Project	IEEE 802.16 Broadband Wireless Access Working Group < http://ieee802.org/16 >	
Title	Frame Structures for 7MHz and 8.75MHz Channel Bandwidths	
Date Submitted	2009-03-02	
Source(s)	Jaeweon Cho, Hoky Choi, Heewon Kang, Jeongho Park, Hwasun Yoo, Jaehee Cho Samsung Electronics Co., Ltd.	Voice: +82-31-279-5796 E-mail: jaeweon.cho@samsung.com
Re:	“802.16m AWD” IEEE 802.16m-09/0012, “Call for Contributions on Project 802.16m Amendment Working Document (AWD) Content” – Call for Comments on Amendment Working Document.	
Abstract	This contribution proposes frame structures for 7MHz and 8.75MHz channel bandwidths.	
Purpose	To be discussed and adopted by TGM for the 802.16m AWD.	
Notice	<i>This document does not represent the agreed views of the IEEE 802.16 Working Group or any of its subgroups. It represents only the views of the participants listed in the “Source(s)” field above. It is offered as a basis for discussion. It is not binding on the contributor(s), who reserve(s) the right to add, amend or withdraw material contained herein.</i>

Frame Structures for 7MHz and 8.75Mhz Channel Bandwidths

Figure xxx Frame Structure with type-1, type-3 and type-4 subframes in TDD duplex mode for 8.75 MHz channel bandwidths ($CP=1/8 T_u$)

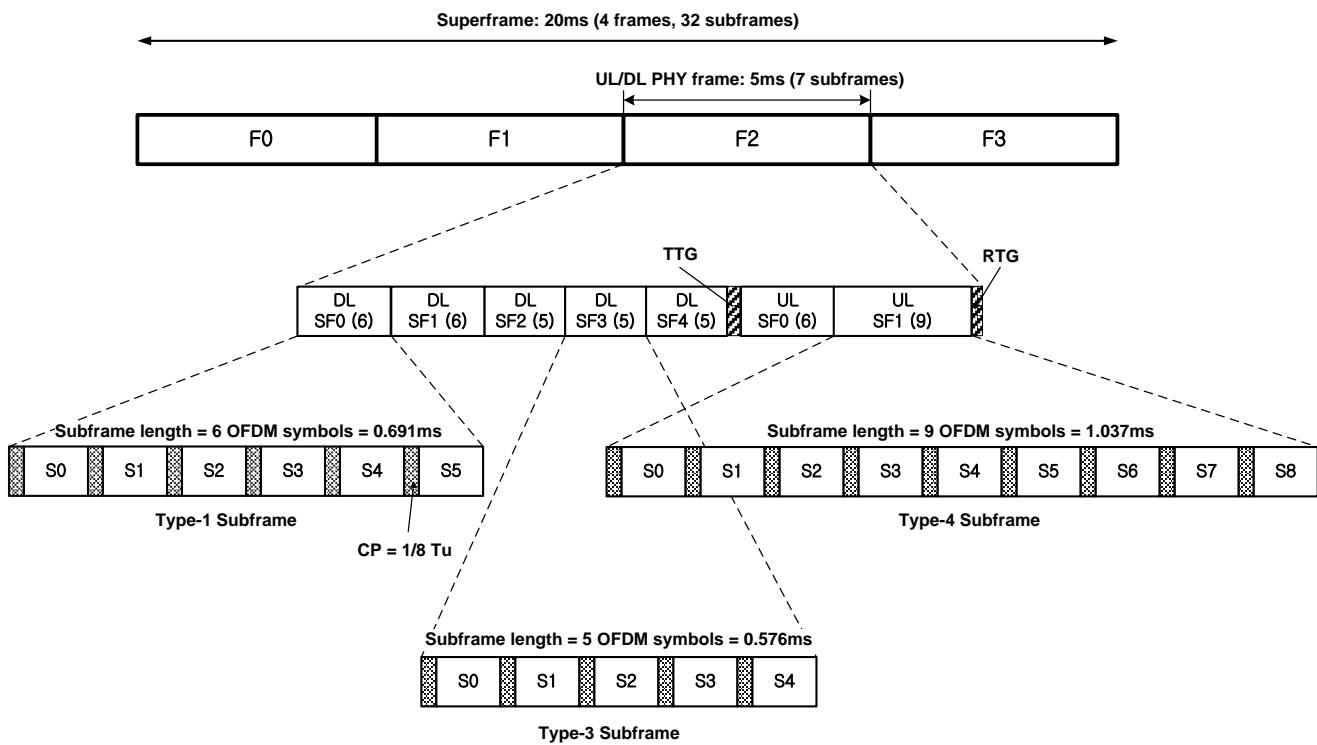
[Remedy 3: Insert the following text and Figure after Figure 391 in page 17]

Figure xxx illustrates an example TDD frame structure with $D:U = 5:2$, which is applicable to the nominal channel bandwidth of 8.75MHz with $G = 1/8$. In Figure xxx the first and second DL subframes and the first UL subframe are type-1 subframes, the other DL subframes are type-3 subframes, and the last UL subframe is a type-4 subframe. TTG and RTG are 87.2 μ s and 74.4 μ s, respectively.

Figure yyy Frame Structure with type-1 and type-3 subframes in TDD duplex mode for 7 MHz channel bandwidths ($CP=1/8 T_u$)

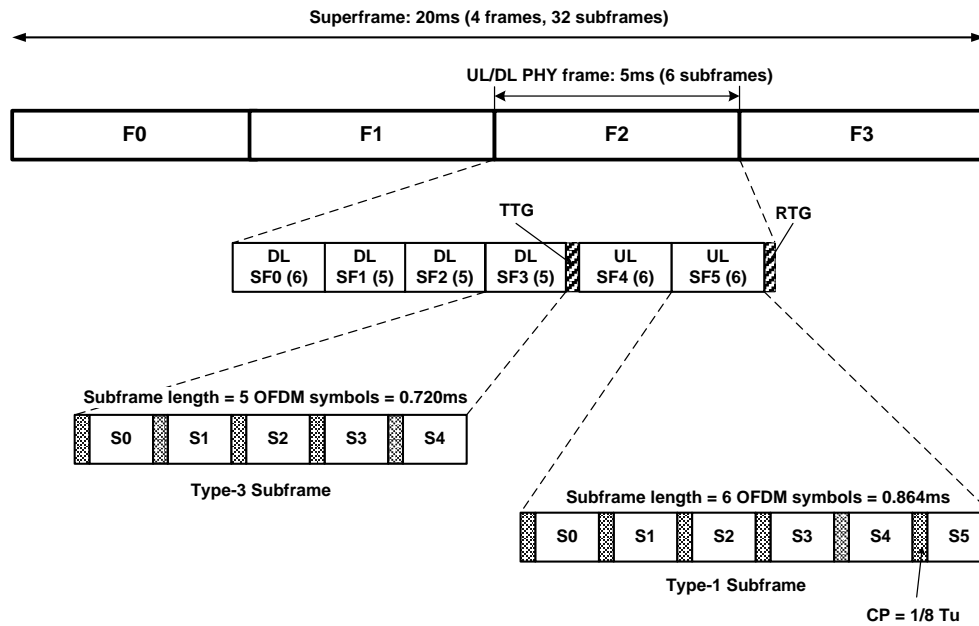
[Remedy 4: Insert the following text and Figure after Figure 391 in page 17]

Figure yyy illustrates an example TDD frame structure with $D:U = 4:2$, which is applicable to the nominal channel bandwidth of 7MHz with $G = 1/8$. In Figure yyy the first DL subframe and all UL subframes are type-1 subframes, and the other DL subframes are type-2 subframes. TTG and RTG are 188 μ s and 60 μ s, respectively.
